ADDENDUM NO. 2
WATER SYSTEM IMPROVEMENTS
CONTRACT 16-03
SNELL BRANCH SEWAGE PUMPING STATION RENOVATION
LEWISBURG, TENNESSEE
WAUFORD PROJECT NO. 1942

Date of Addendum: Monday, October 23, 2017

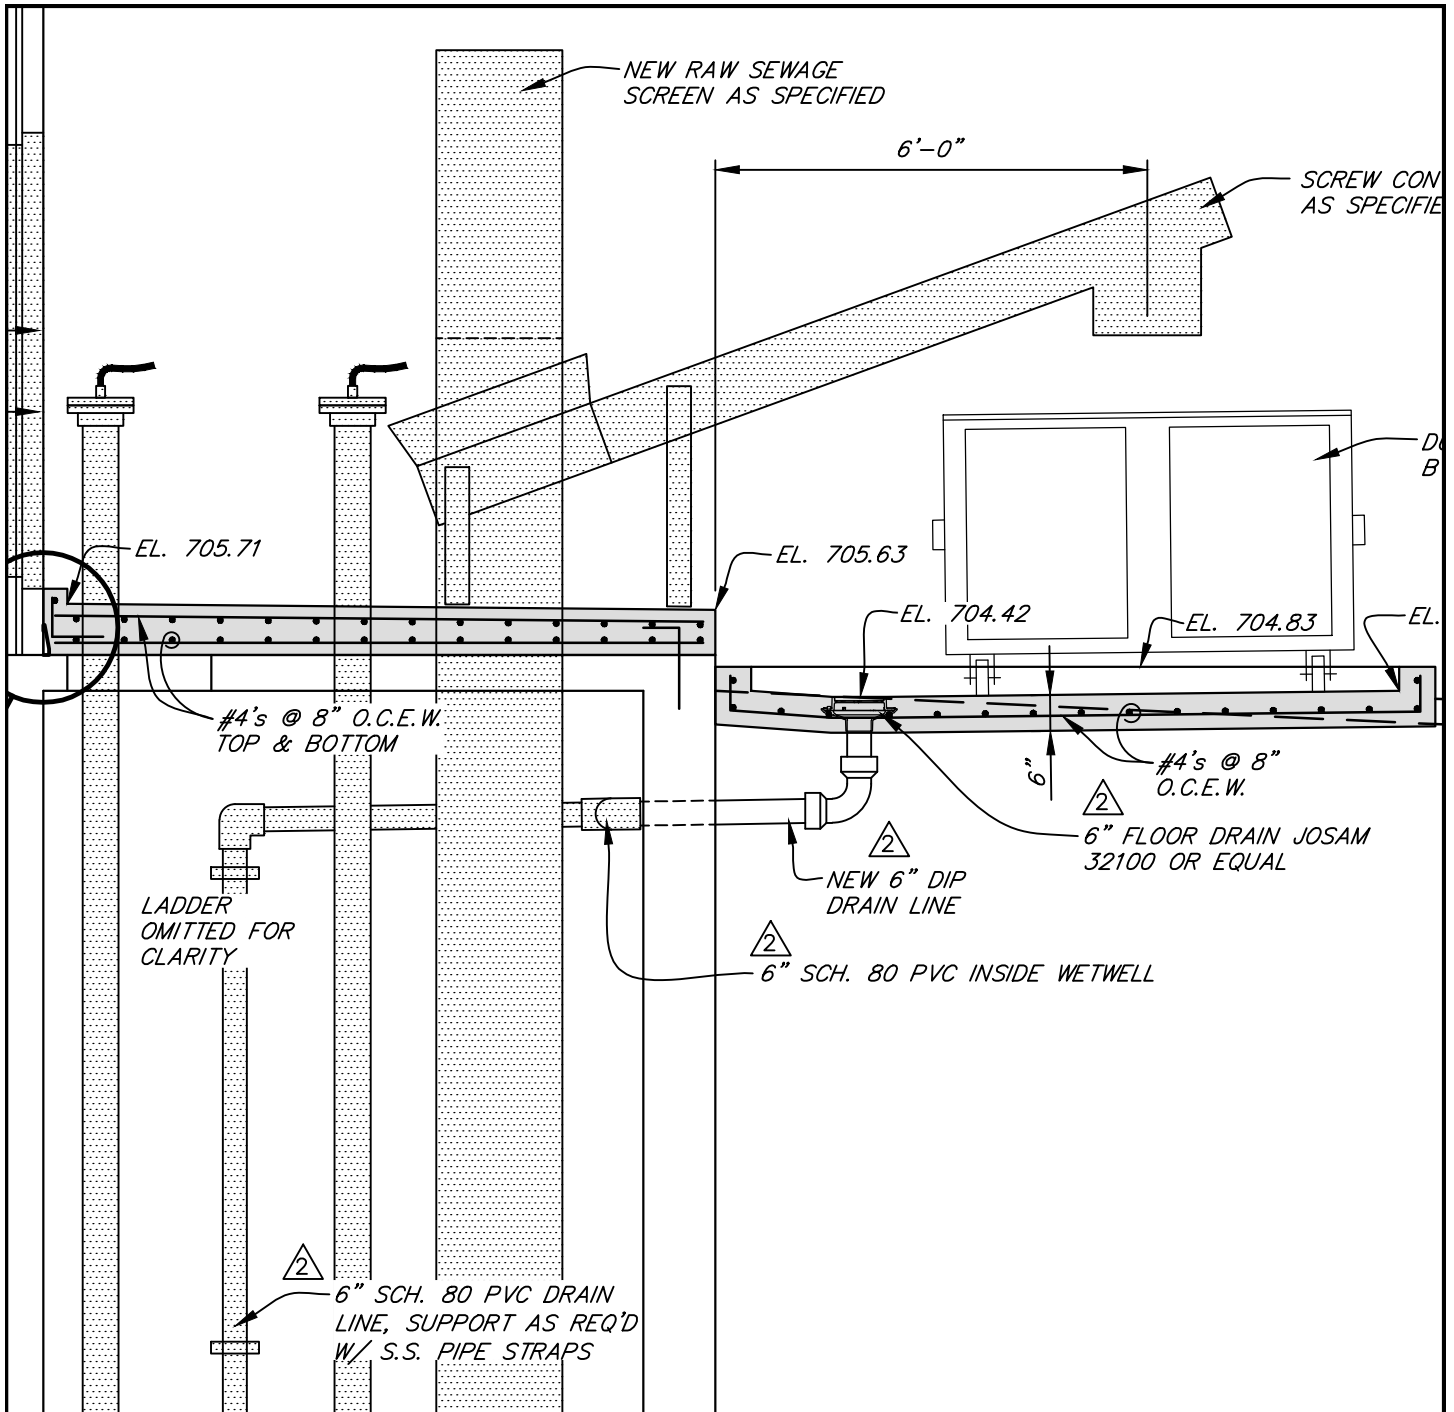
6. Plans, Sheets 3 and 4:

Add the following construction note:

7. Plans, Sheet 4:

Revised as shown on the attached 8 ½" x 11" sheets.

- “7. All ductile iron pipe used for gravity drains shall be specially lined inside equal to Protecto 401.”
